ADDENDUM NO. 1

Town of Montville
Public Works Drainage Improvements
2020-5

ADDENDUM ISSUED: April 27, 2020

ADD-1

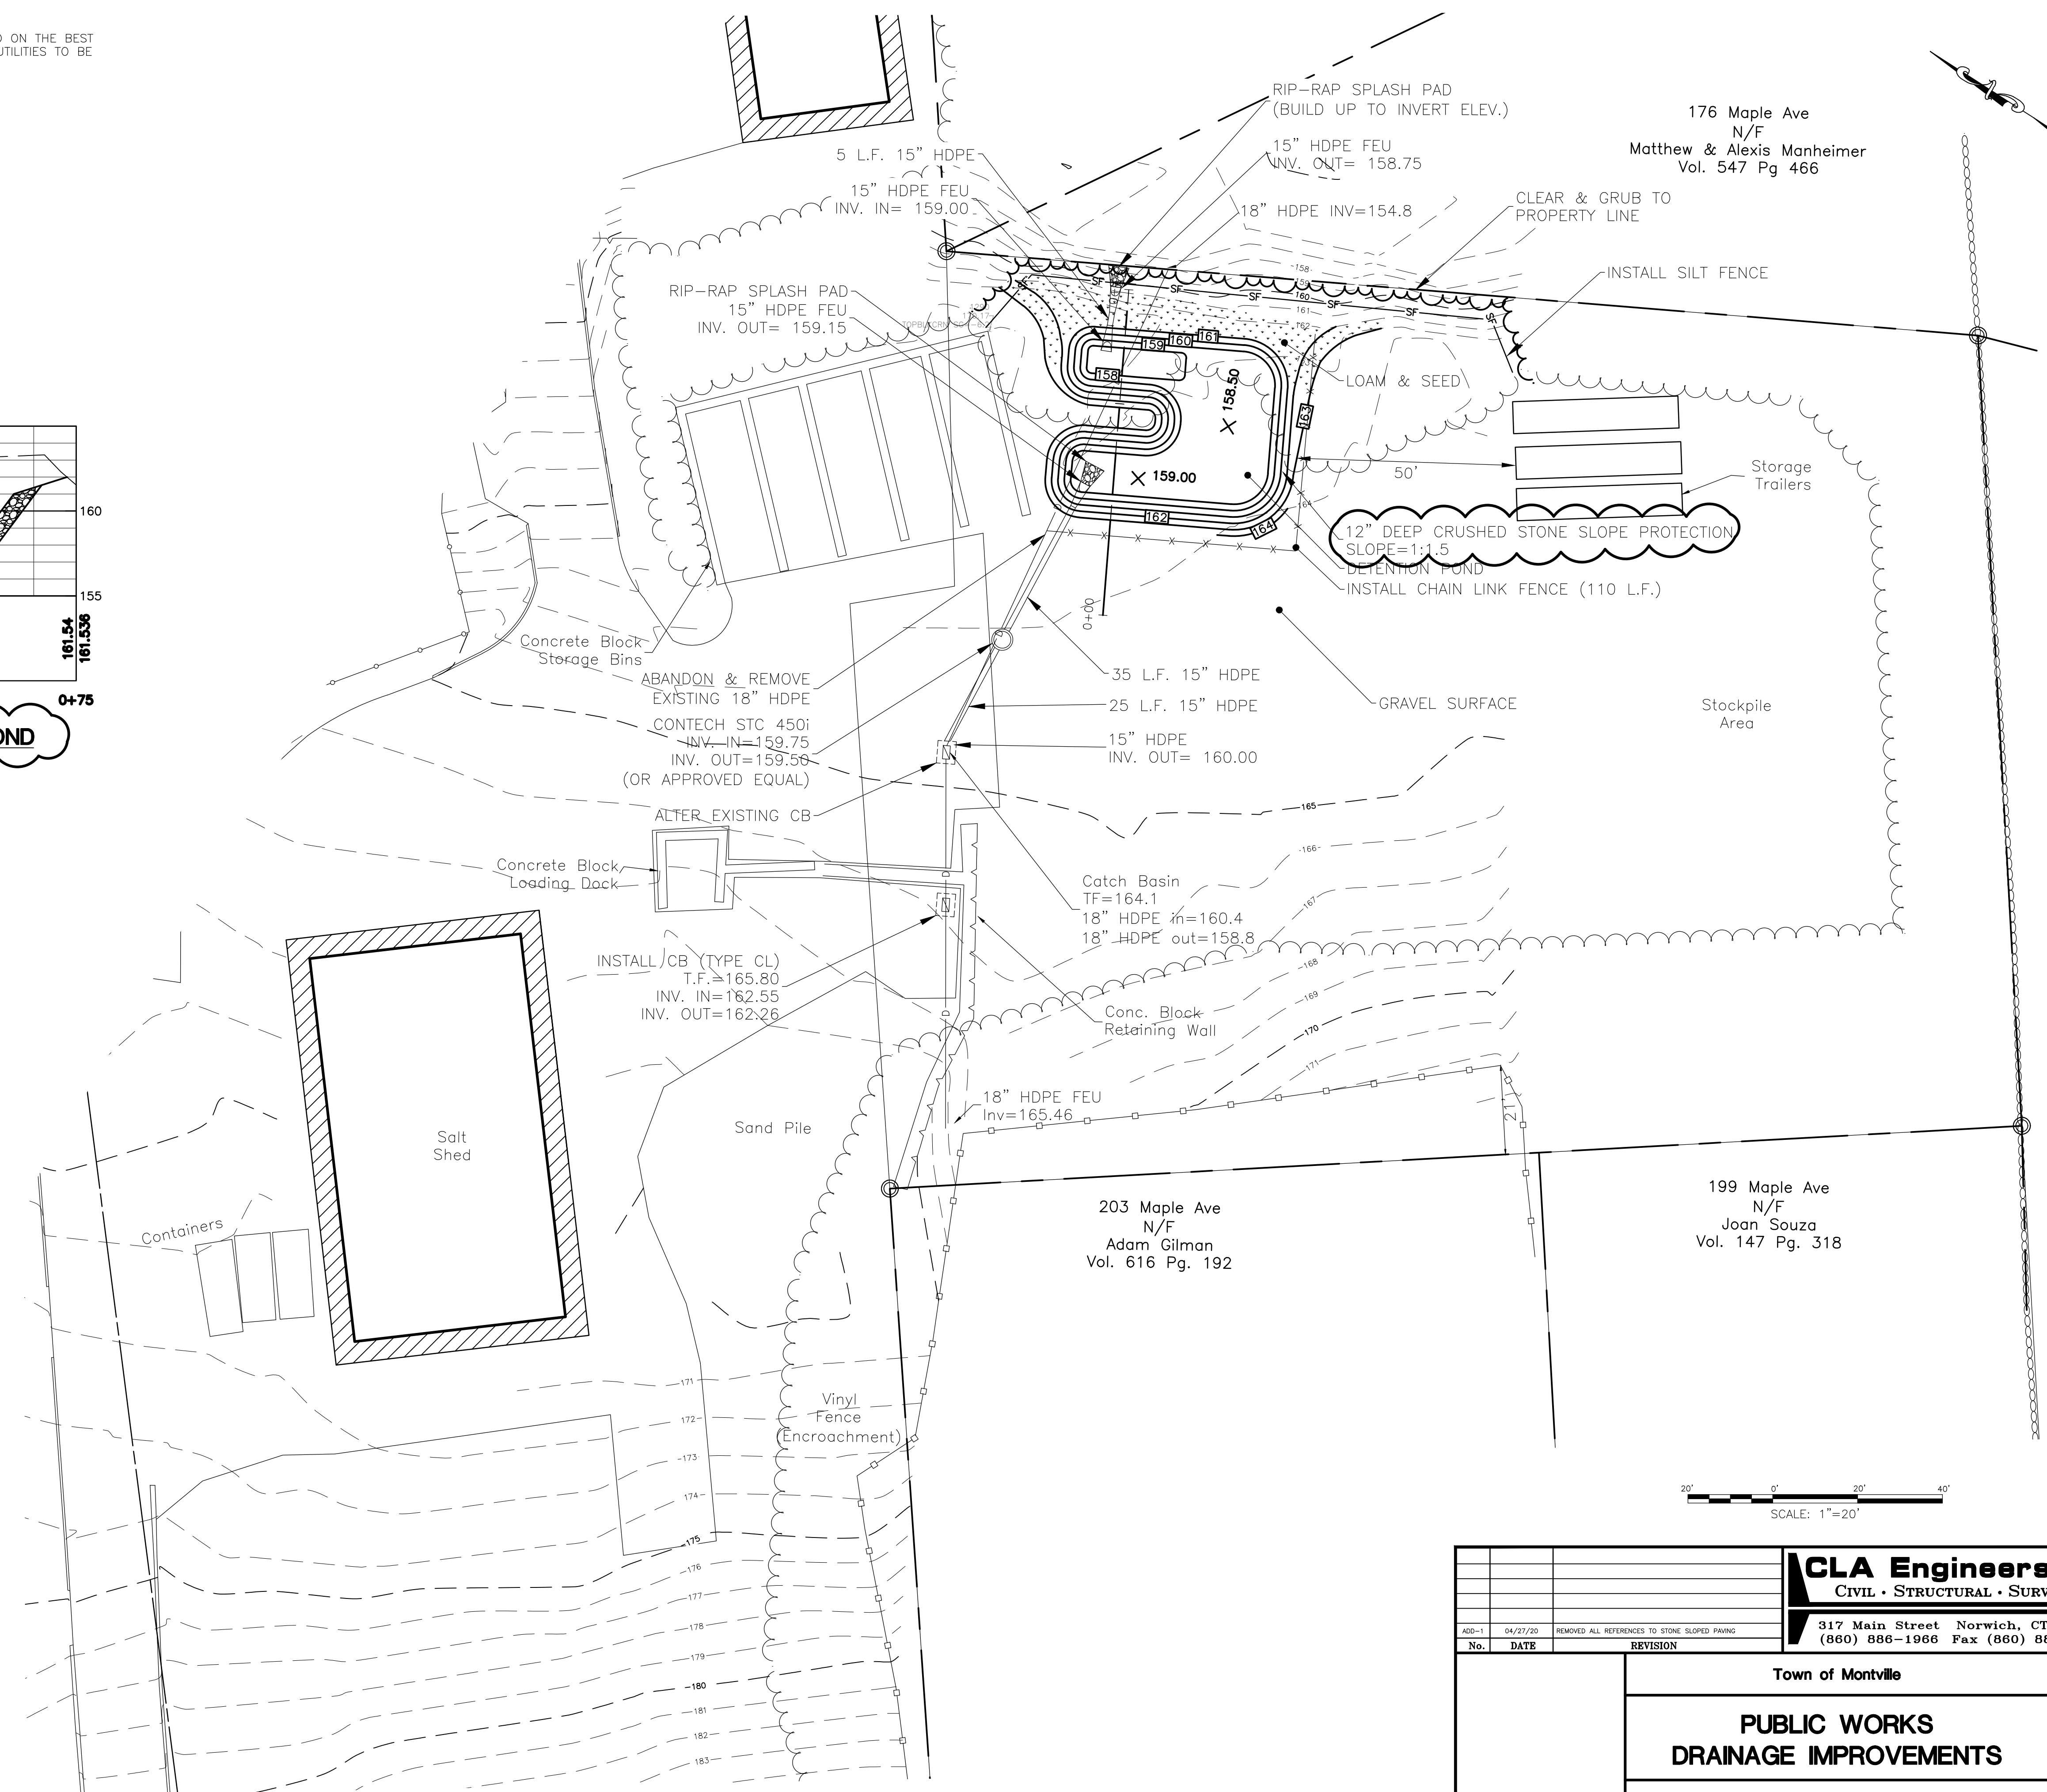
1. Sheet 1 – Layout Plan: DELETE Layout Plan in its entirety and replace with Layout Plan ADD-1.
 - a. Removed references to stone sloped paving.

CRUSHED STONE SLOPE (12" DEEP)
SLOPE=1:1.5 (TYP.)

CRUSHED STONE SLOPED DETENTION POND
